**Validation report form for post-registration changes for
CDM project activities
(Version 02.0)**

Title and UNFCCC reference number of the project activity	Jilin Fuyu Sanjingzi Phase I Wind Farm Project
Process track	<input type="checkbox"/> Prior approval <input checked="" type="checkbox"/> Issuance <input type="checkbox"/> Renewal of crediting period
Version number of the validation report on PRCs	01
Completion date of the validation report on PRCs	05/01/2019
Type(s) of PRCs	<input type="checkbox"/> Temporary deviations from the registered monitoring plan, monitoring methodology or standardized baseline <input type="checkbox"/> Corrections <input type="checkbox"/> Changes to the start date of the crediting period <input type="checkbox"/> Inclusion of a monitoring plan to a registered project activity <input checked="" type="checkbox"/> Permanent changes from registered monitoring plan, monitoring methodology or standardized baseline <input type="checkbox"/> Changes to the project design of a registered project activity <input type="checkbox"/> Types of changes specific to afforestation and reforestation project activities

Shenzhen CTI International Certification Co., Ltd (CTI)

Fig 1 Comparison of the monitoring system between the registered PDD and Revised PDD

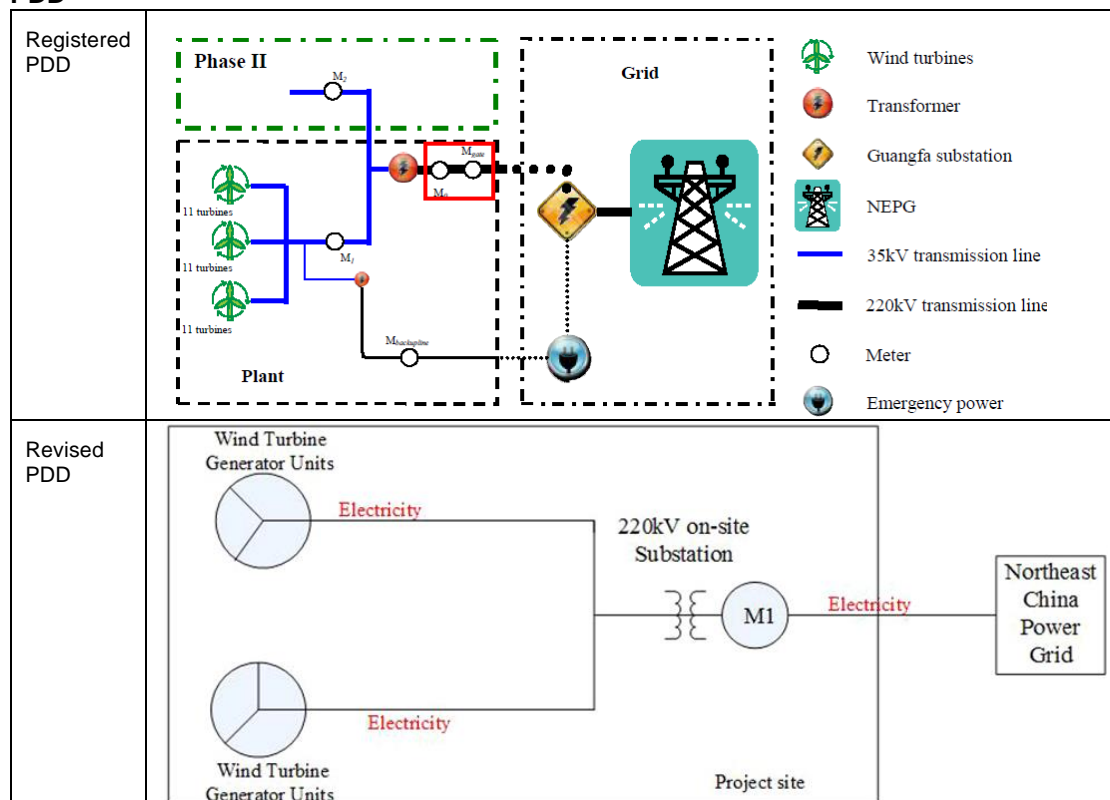
Means of validation	<p>The post-registration changes to the registered monitoring plan is identified during the process performing the 1st verification of Jilin Fuyu Sanjingzi Phase I Wind Farm Project. The changes are assessed in accordance with applicable validation requirements related to the permanent changes from the registered monitoring plan in the CDM validation and verification standard for project activities as below:</p> <p>As per the registered monitoring plan, two bi-directional meters (M_{gate}, M_0) will be installed to monitor $EG_{export,y}$ and $EG_{import,y}$. M_0 works as backup meter for M_{gate} when there is failures in M_{gate}, M_0 will be used. After the second phase connected to the same transformer, the M_{gate} and M_0 will be used to monitor electricity imported and exported from both two projects. Then, M_1 which monitors electricity from the proposed project (phase I) will be implemented with M_2 which monitors electricity from phase II to calculate the exported and imported electricity from the proposed project as $M_{gate} * M_1 / (M_1 + M_2)$. M_1 and M_2 are also bi-directional meters. In order to monitor the electricity imported for black start, one meter ($M_{backupline}$) will be installed to monitor $EG_{backupline,y}$. The accuracy of the all the meters must be 0.5 or more precise.</p> <p>After the proposed project registered, it has been operated completely on 12/10/2014. As per the requirement of the Grid Company /4/, a meter (M_1) has been installed at high volt side of 220kV on-site Substation to monitor the electricity supplied to NECPG by the proposed project ($EG_{export,y}$) and the electricity imported from NECPG by the proposed project ($EG_{import,y}$). Contrast to registered PDD, there is no back line with the back meter to monitor its export and</p>

import electricity, monitoring parameter $EG_{\text{backupline}, y}$ is not existed correspondingly. (as shown in Fig 1 below).

Corresponding to the changes of the monitoring structure, the monitoring for the parameters $EG_{\text{export}, y}$ (electricity exported to the grid by the project) and $EG_{\text{import}, y}$ (electricity imported from the grid to the project) changed from directly measured by the meter M1 installed at the high volt side of 220kV on-site Substation to be calculated based on the measured values of the meters as below:

Findings	<p>CAR 1: In the registered PDD, it stated that “two bi-directional meters (M_{gate}, M_0) will be installed to monitor $EG_{export,y}$ and $EG_{import,y}$. M_0 works as backup meter for M_{gate} when there is failures in M_{gate}, M_0 will be used. After the second phase connected to the same transformer, the M_{gate} and M_0 will be used to monitor electricity imported and exported from both two projects. Then, M_1 which monitors electricity from the proposed project (phase I) will be implemented with M_2 which monitors electricity from phase II to calculate the exported and imported electricity from the proposed project as $M_{gate} * M_1 / (M_1 + M_2)$. M_1 and M_2 are also bi-directional meters. In order to monitor the electricity imported for black start, one meter ($M_{backupline}$) will be installed to monitor $EG_{backupline, y}$. The accuracy of the all the meters must be 0.5 or more precise.” However, by on-site visit, CTI found that a meter (M_1) has been installed at the high volt side of 220kV on-site Substation to monitor the total electricity supplied to the grid by the proposed project and the imports from the grid by the proposed project. Contrast to registered PDD, there is no back line with the back meter to monitor its export and import electricity, monitoring parameter $EG_{backupline, y}$ is not existed correspondingly. (Refer to Appendix 4)</p>

CAR ID	1	Section no.	D.6	Date: 03/01/2019
Description of CAR				
In the registered PDD, it stated that "two bi-directional meters (M_{gate} , M_0) will be installed to monitor $EG_{export,y}$ and $EG_{import,y}$. M_0 works as backup meter for M_{gate} when there is failures in M_{gate} , M_0 will be used. After the second phase connected to the same transformer, the M_{gate} and M_0 will be used to monitor electricity imported and exported from both two projects. Then, M_1 which monitors electricity from the proposed project (phase I) will be implemented with M_2 which monitors electricity from phase II to calculate the exported and imported electricity from the proposed project as $M_{gate} * M_1 / (M_1 + M_2)$. M_1 and M_2 are also bi-directional meters. In order to monitor the electricity imported for black start, one meter ($M_{backuptime}$) will be installed to monitor $EG_{backuptime, y}$. The accuracy of the all the meters must be 0.5 or more precise." However, by on-site visit, CTI found that a meter (M_1) has been installed at the high volt side of 220kV on-site Substation to monitor the total electricity supplied to the grid by the proposed project and the imports from the grid by the proposed project.

- the accuracy of the meter M1 meets the requirement of the registered and Revised monitoring plan;
- the monitoring means of $EG_{\text{export}, y}$ and $EG_{\text{import}, y}$ is reasonable.

Project participant response				Date: 03/01/2019
There are permanent changes to the registered monitoring plan, Changes that are being submitted with this monitoring report as part of the request for issuance (post-registration change - issuance track) as applicable from this monitoring period.				
Documentation provided by project participant				
Diagram of power connection system				
DOE assessment				Date: 03/01/2019
The Revised PDD has been provided by PP to indicate the permanent changes in the monitoring system. The Verification Team confirms the updated monitoring system is consistent with the actual condition and according to the requirement of the Grid Company. As per the Ver.02.0 of CDM project standard for project activities, these changes do not need to get the prior approval from EB. Therefore, the Revised PDD will be submitted following the verification documents. CAR 1 is closed.
